INQUIRY INTO CROSS CITY TUNNEL

LANE COVE COUNCIL

**JOINT SELECT COMMITTEE
ON THE CROSS CITY TUNNEL**

THE LANE COVE TUNNEL

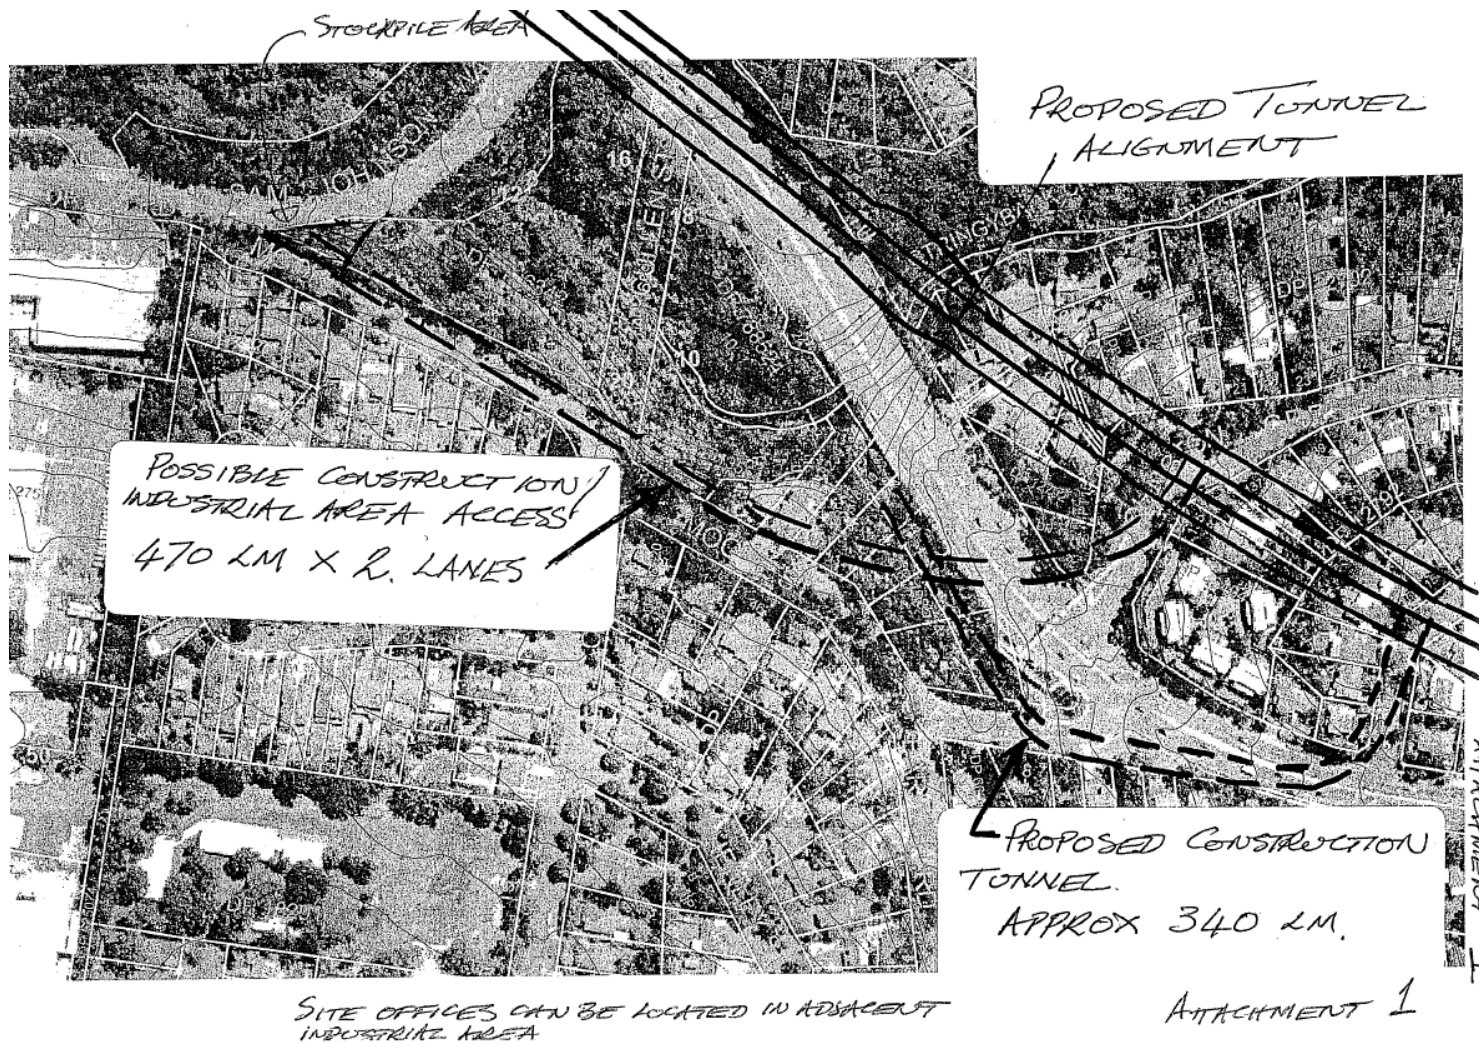
Drawing No. C014, issue P4, sheet 6, Typical Cross Sections of Epping Road shows typical cross sections of Epping Road between Centennial Avenue and Parklands Avenue. It indicates that in many locations the through traffic lanes are 2.8 and 2.9 metres wide and the bus lane at 3.0 metres whereas the cross section closest to the centre of the azalea plantings are 3.0 metres wide and the bus lane 3.5 metres wide. Design standards also provide that the bike lane can be a minimum of 2.8 metres wide.

While the footpath on the north side of the road is only about 2.1 metres wide between the kerb and the wall along the base of the garden area, Council considers that the width of 3.5 metres proposed is completely unnecessary. The combination of excessive lane widths on the roadway and the excessive footpath width will take 2.85 metres off the front of the garden and will completely destroy the existing garden bed. It would result in a retaining wall between 1.5 metres and 2.5 metres high depending on whether the second wall at the top of the grassed slope falls within the new footpath area.

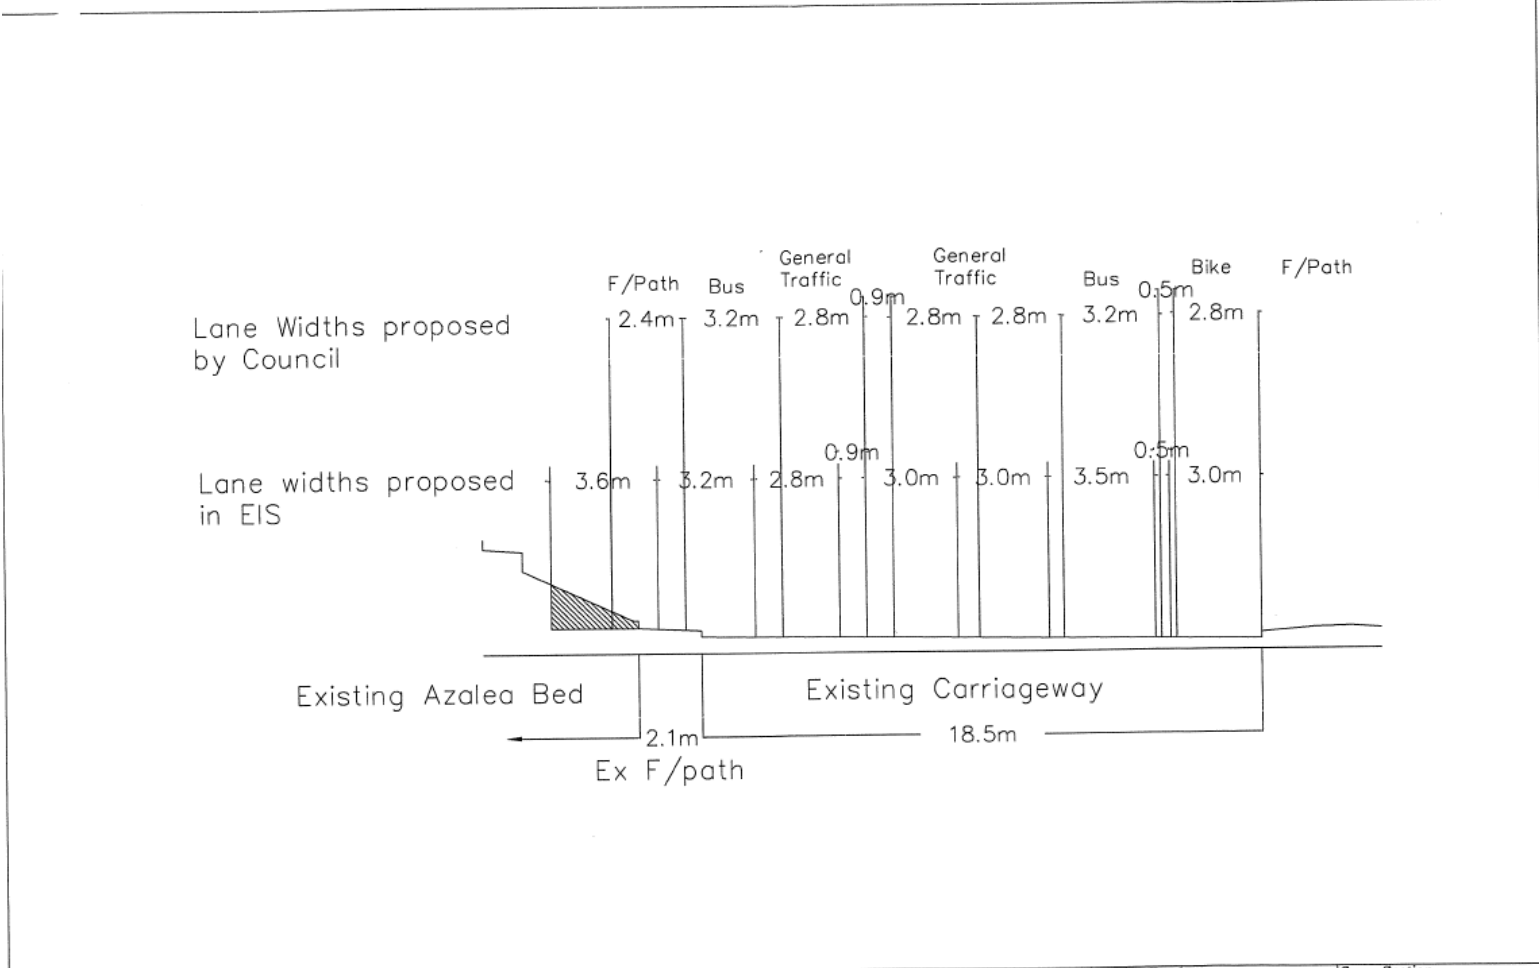
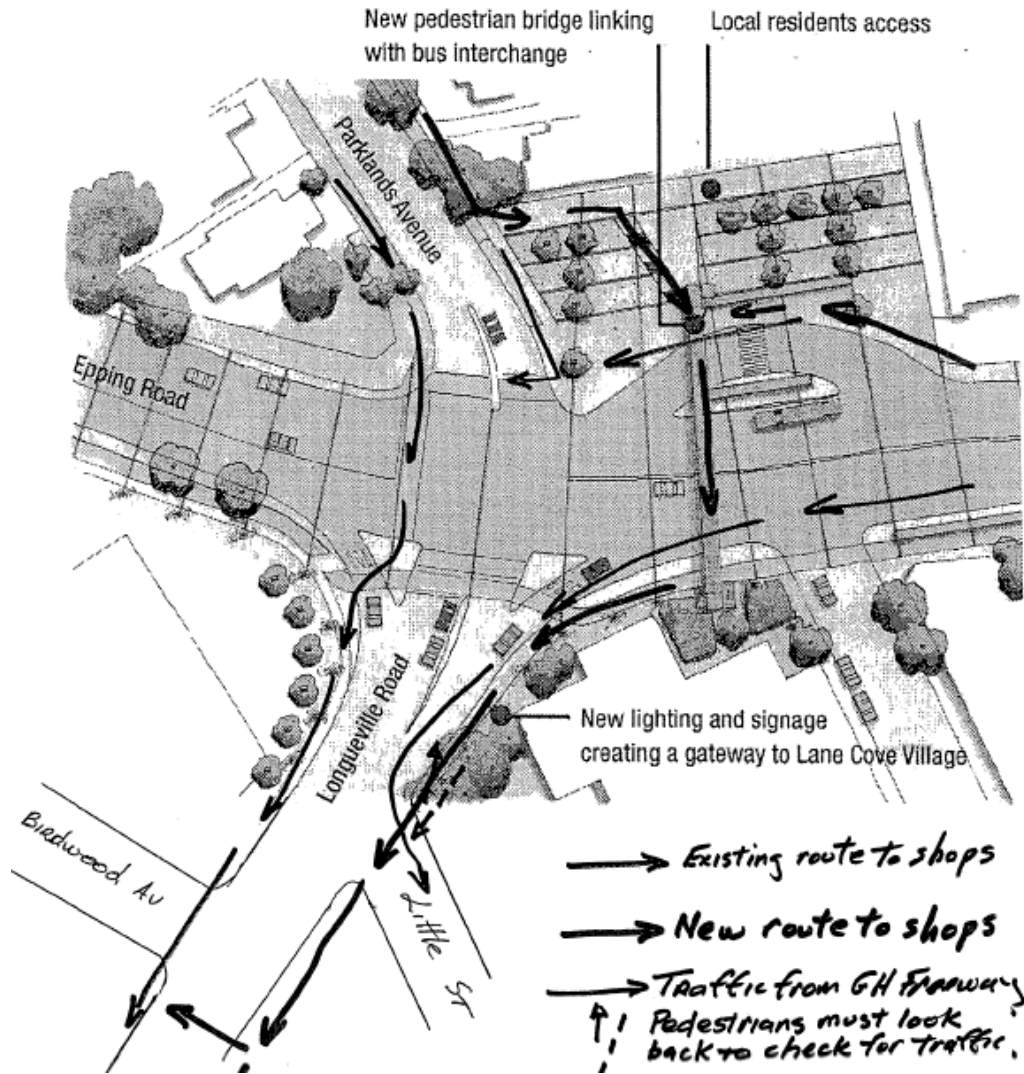
If the road at this location was redesigned to provide the reduced traffic lane widths of 2.8 metres, bus lanes of 3.2 metres and the bike lane at 2.8 metres, the roadway width could be reduced by 0.9 metres. A footpath width of 2.4 metres would be sufficient for this section of footpath reducing the impact on the garden bed by a further 1.1 metres. In short, the impact on the garden beds could be reduced from 2.85 metres to 0.8 metres. Although this would still necessitate the reconstruction of the formal beds spelling out "Lane Cove", they could be reconstructed in a similar style as that existing.

The concrete retaining wall shown in the EIS is not only wrong in scale (shown waist high rather than 2.0 metres) but the material proposed is completely out of character with that existing. Any reconstruction of retaining walls should be in material consistent with existing materials.

Attachment 8 – Figure 4.6 from Appendix C

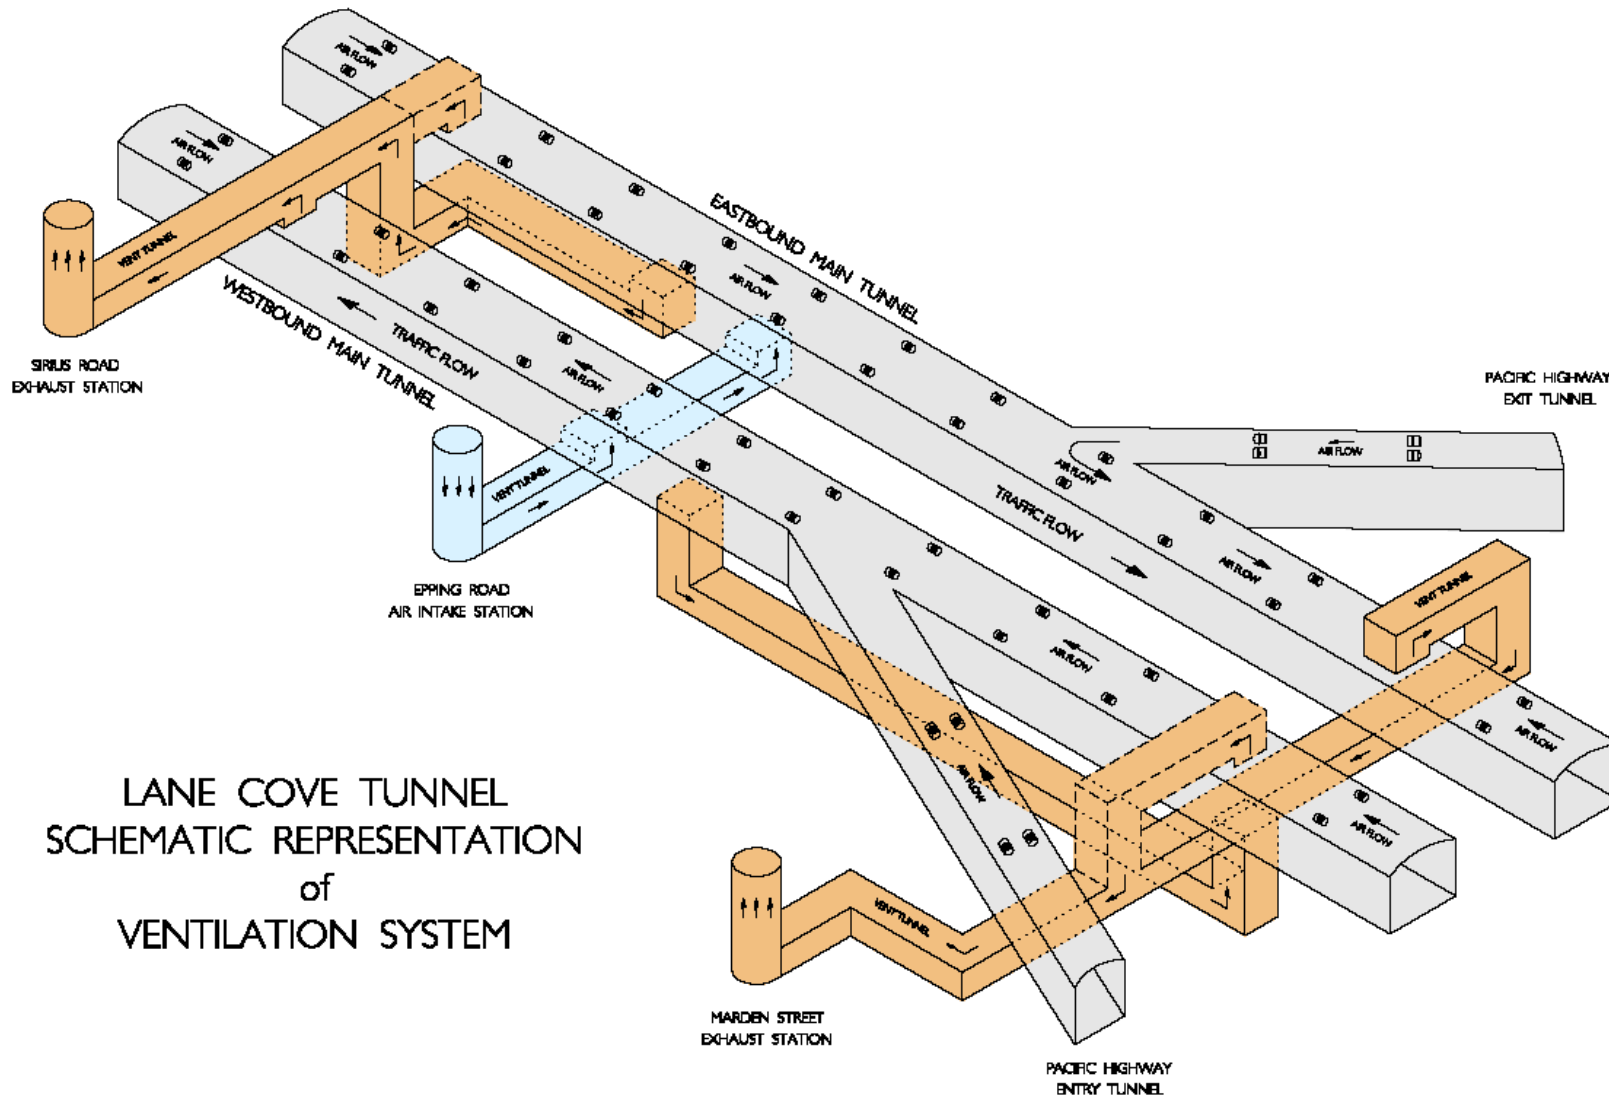
648
649 Although the RTA agreed at the 12 May 2004 meeting to provide the changed air
650 flows for the modified ventilation for comparison with the approved ventilation in Fig
651 4.6 of Appendix C, **RTA subsequently refused to provide that data as TJH were**
652 **finalizing their ventilation design in Hong Kong.** **Attachment 20** on page 116
653 refers to the relevant correspondence with RTA.

- 812 • **CAER claims that the approved ventilation concept design was shown in**
813 **Appendix A. Although diagrammatic, failed to document the reduction in air**
814 **flows, number of fans or cross sectional areas of the ventilation tunnels and**
815 **stack compared to Figure 4.6 of Appendix C.**
816

FIGURE 8

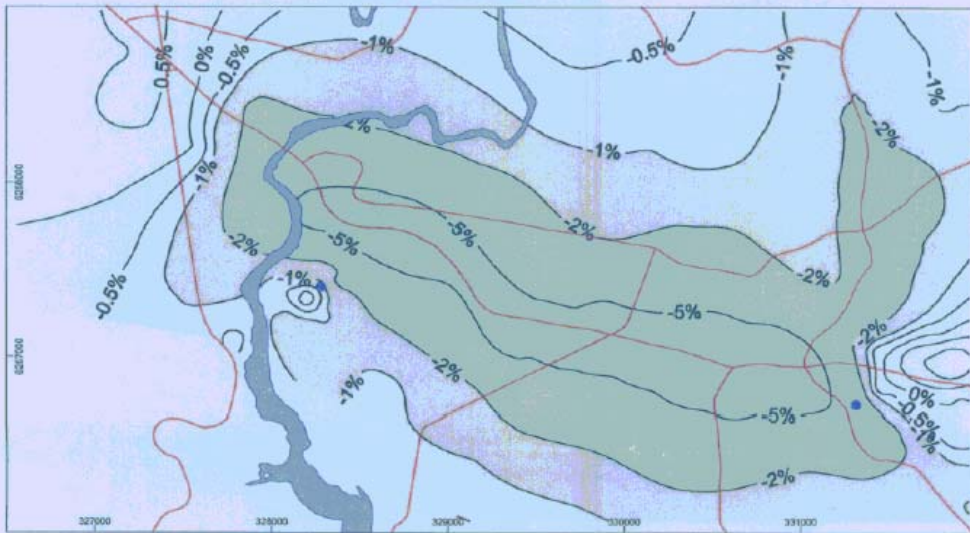
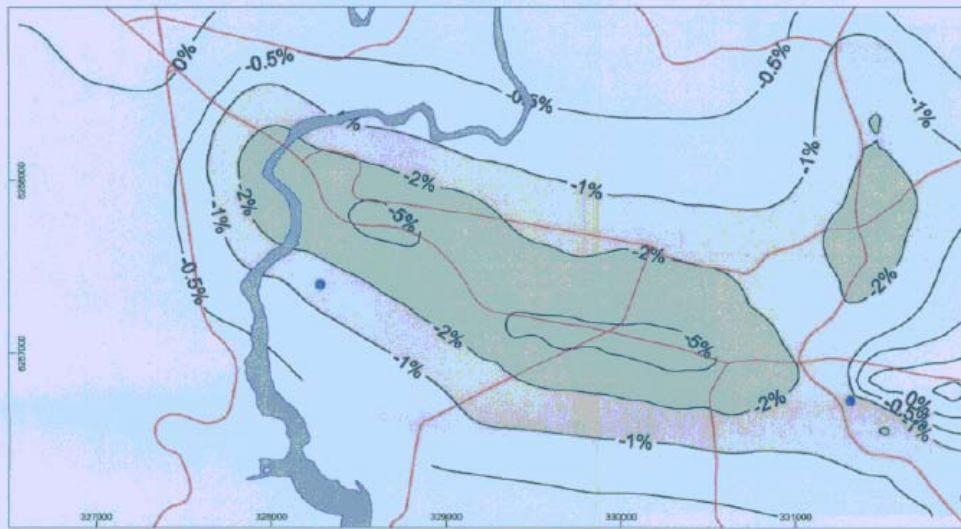
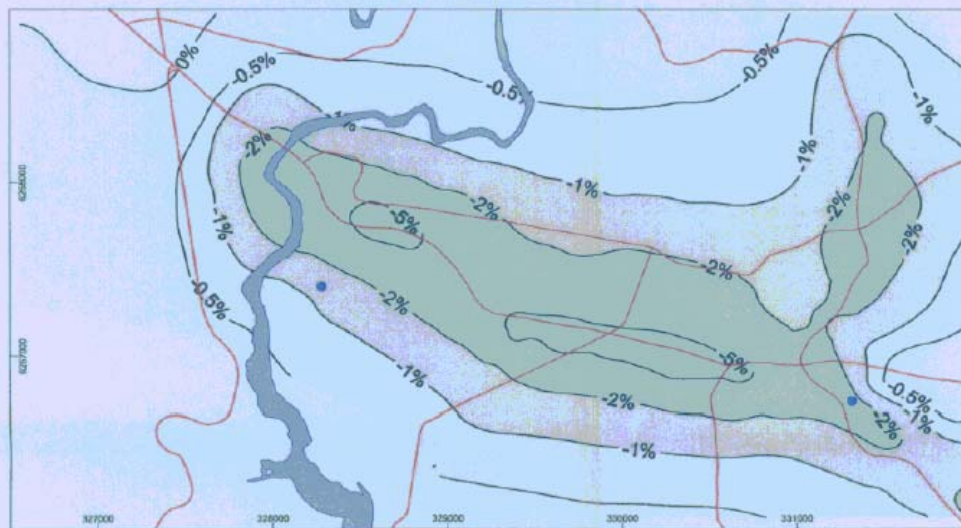
- d) 700 vph/lane at 5 km/hour was used as a worst congestion case
What is the decay relationship for emissions in gm/km/vehicle between 5 and 20 km/hr for grades applicable to the Lane Cove Tunnel?
- e) The contours for changes in maximum concentrations presented in Figures 4-9 are at a scale hard to read.
- i) Is it possible to have each figure reproduced on A3 page? and
 - ii) Is it also possible to provide the contours of maximum concentrations due to the stack alone for both HAS 2002 and HAS 2004?

Contours of maximum concentrations due to the stack alone (ie reductions in emissions for local roads not included) for the detailed design has been provided by TJH.

Copies of Figures 8 and 9, in colour, are attached for Councils information as requested.

Attachment 26 – Diagram Outlining Changes in Ventilation

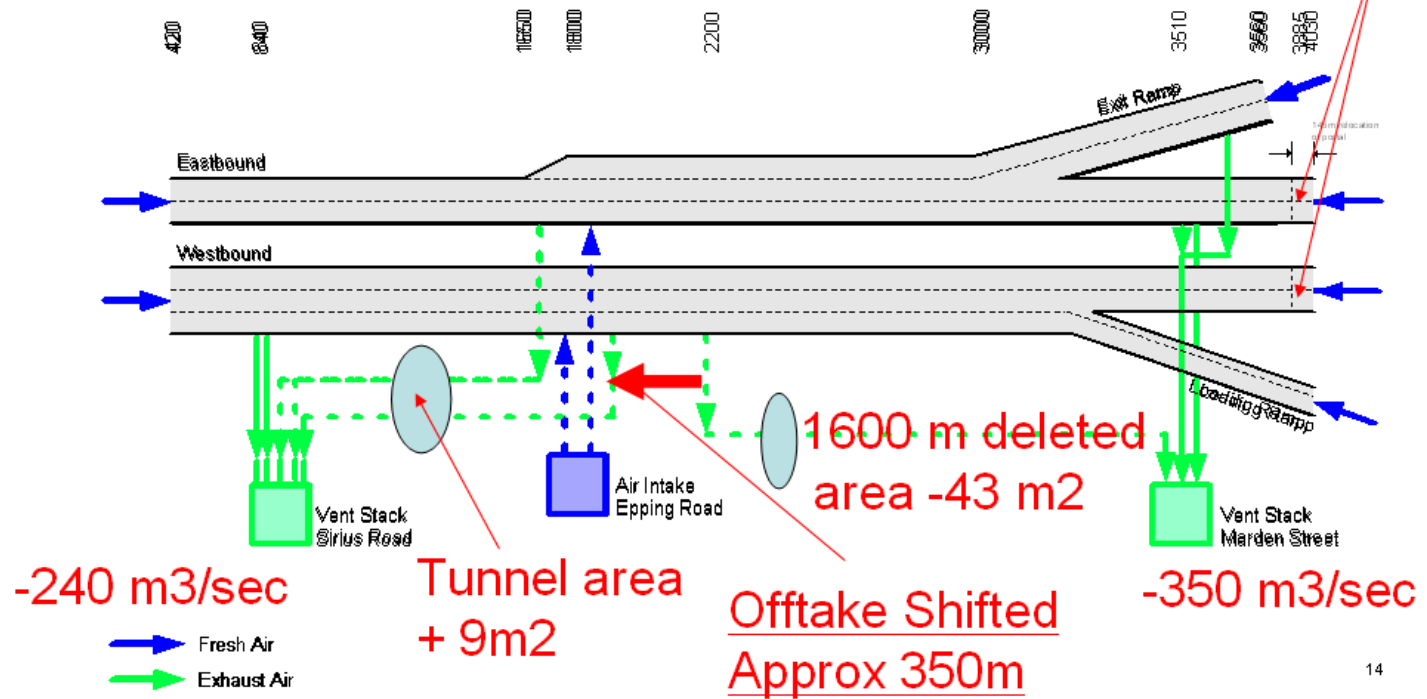
Ventilation Concept Design – Approved **relative to Revised Free Flowing one tunnel - congested the other**
